**Re: Application for Amendment to Form of Transmission Connection
Agreement – McLean’s Mountain Wind Limited Partnership
Board File No. EB-2013-0367**

RE: McLean's Mountain Wind Limited Partnership Application to Amend Connection Agreement with Hydro One Networks Inc.

RE: *McLean's Mountain Wind Farm*
 Change in Demarcation Point
 CAA ID: 2010-386

McLean's Mountain Wind Farm
18KV SWITCHING STATION
RELAY PROTECTION
SINGLE LINE DIAGRAM

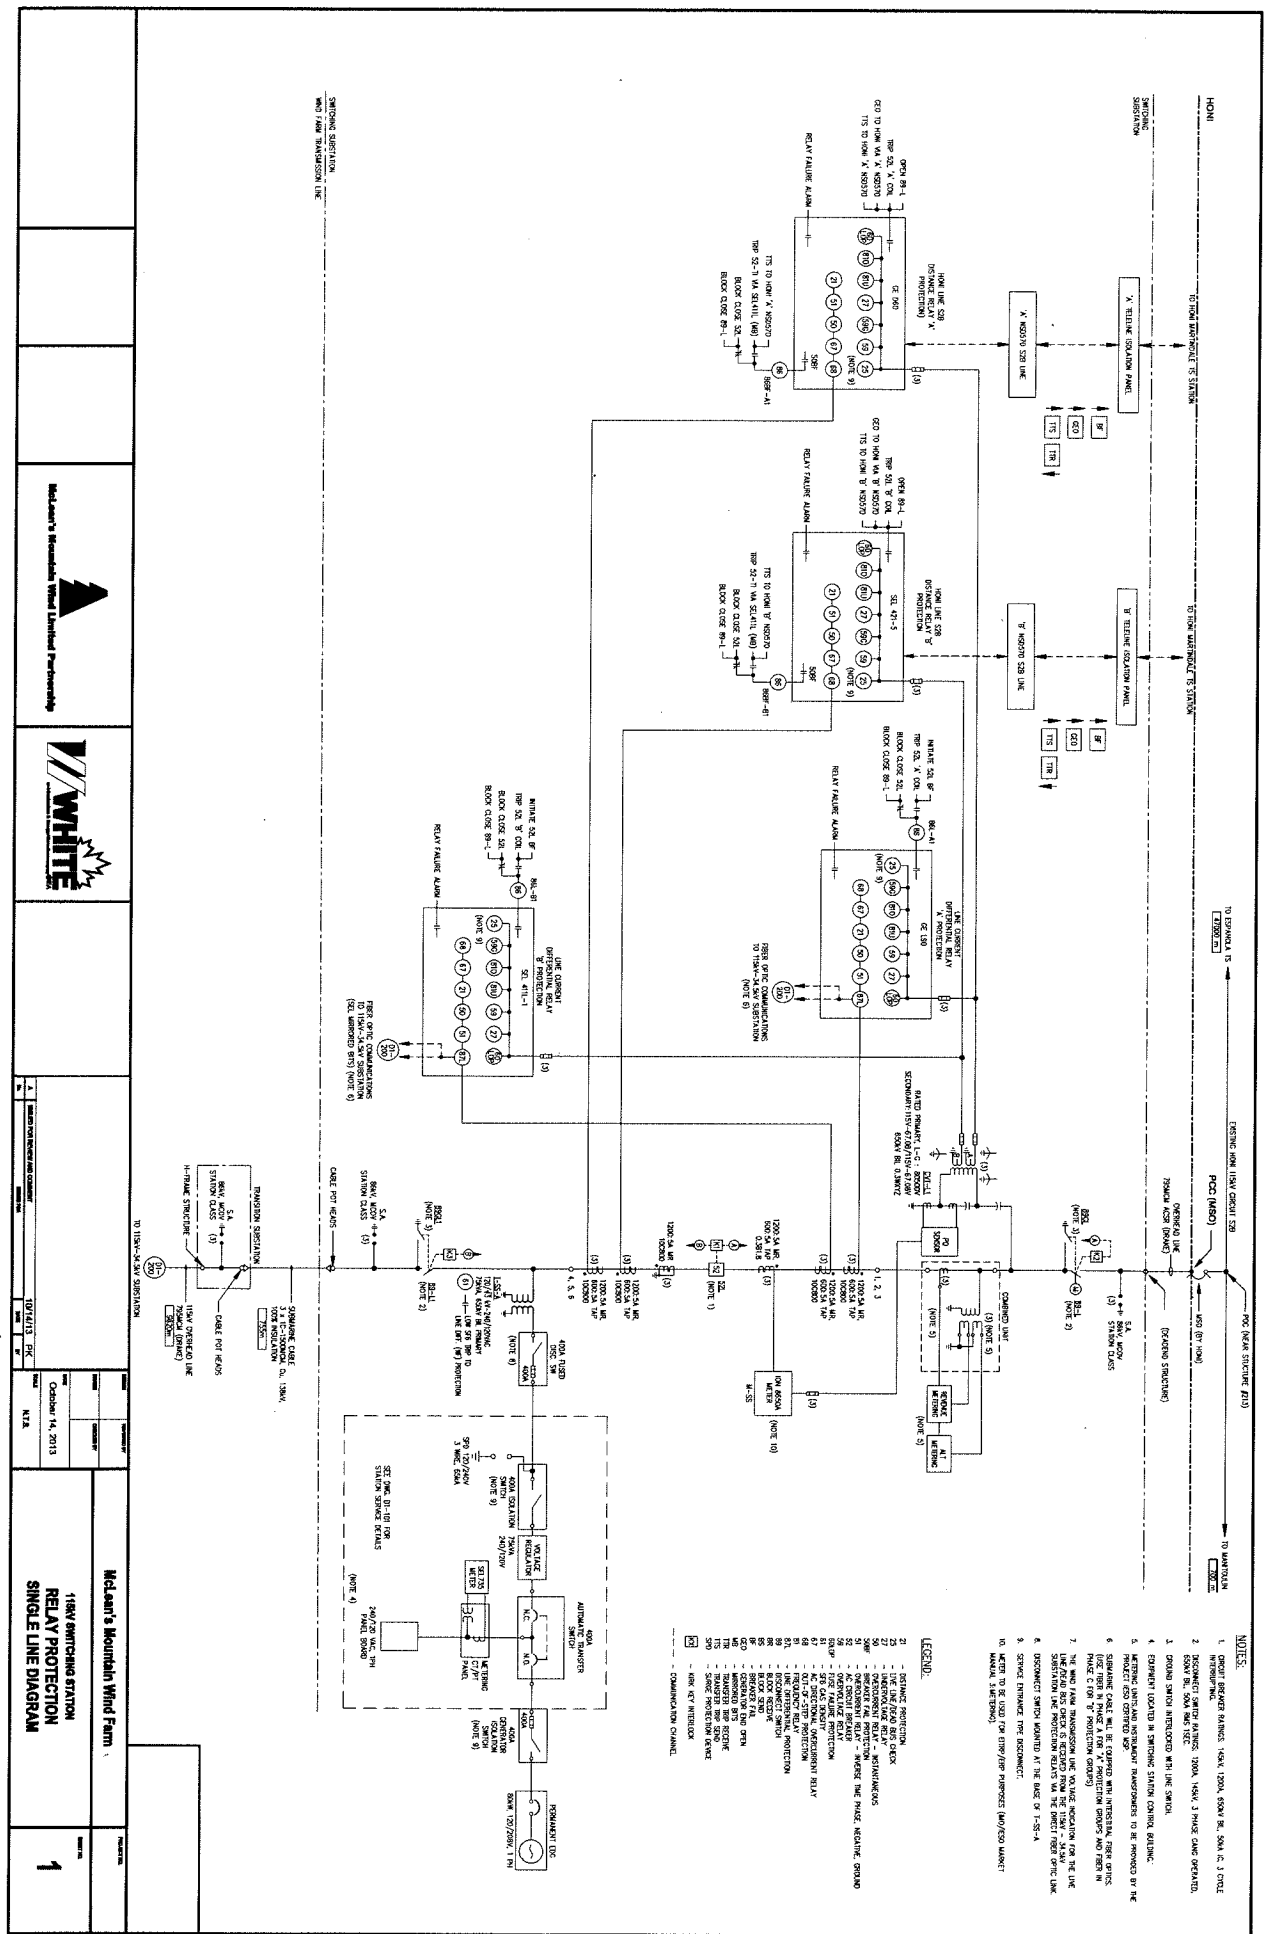
The IESO has reviewed the modification to McLean's Mountain's demarcation point, which has changed in location from the 115 kV disconnect switch to where the mid span openers are located as shown in your single line diagram dated October 14, 2013 and attached to this letter for reference.

The IESO has concluded that the proposed connection will not result in a material adverse impact on the reliability of the integrated power system and will not change the conclusions and findings from the System Impact Assessments and Addendums under CAA ID 2010-386.
